Access Compliance Report

Public Rights-of-Way

Intersection ID: 51481	Main Street: KRISTENS_MARE_DR	Cross Street: ARDWYCK_PL	Location:	E
ADA ID: 6717DA417710	Ramp Type: Perp	Initial Pass/Fail: Fail	Overall Compliance: No	Severity Score: 12.5
Codes/Mitigation Info/Possible Solution		Field Measurements/Component Compliance

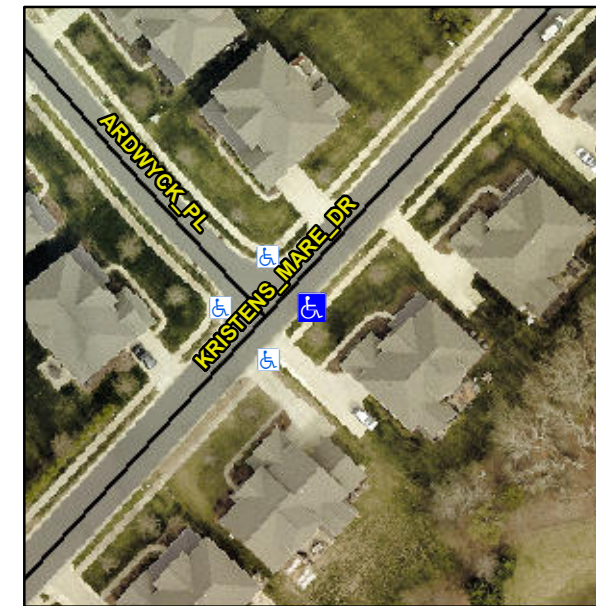
Not Found, R304.2.2

Compliance	Description	Data	Compliance	Description	Data
N/A	Ramp Length (in)	46.0	No	Ramp Slope (%)	11.4
Yes	Ramp Width (in)	48.0	Yes	Ramp XSlope (%)	1.1
N/A	Flare Type LT	N/A	N/A	Flare Type RT	N/A
N/A	Flare Slope LT (%)	N/A	N/A	Flare Slope RT (%)	N/A
N/A	Flare Traversable LT?	N/A	N/A	Flare Traversable RT?	N/A
N/A	Landing Length (in)	N/A	N/A	DWS Provided?	N/A
N/A	Landing Width (in)	N/A	N/A	DWS Contrast?	N/A
N/A	Landing Slope (%)	N/A	N/A	DWS Length (in)	N/A
N/A	Landing X Slope (%)	N/A	N/A	DWS Full Width?	N/A
N/A	Landing Curb? (Y/N)	N/A	N/A	DWS Offset (in)	N/A
N/A	Shared Landing?	N/A			
N/A	Gutter Ponding?	N/A	N/A	Gutter Slope (%)	N/A
N/A	Gutter Lip Ht (in)	N/A	N/A	Gutter X Slope (%)	N/A
N/A	Painted X Walk1?	No	N/A	Painted X Walk2?	N/A
	X Walk 1 Direction	To NW		X Walk 2 Direction	N/A
N/A	X Walk 1 Width (in)	N/A	N/A	X Walk 2 Width (in)	N/A
	X Walk 1 Slope (%)	2.7		X Walk 2 Slope (%)	N/A
	X Walk 1 X Slope (%)	0.8		X Walk 2 X Slope (%)	N/A

Remove & Replace Entire Ramp.
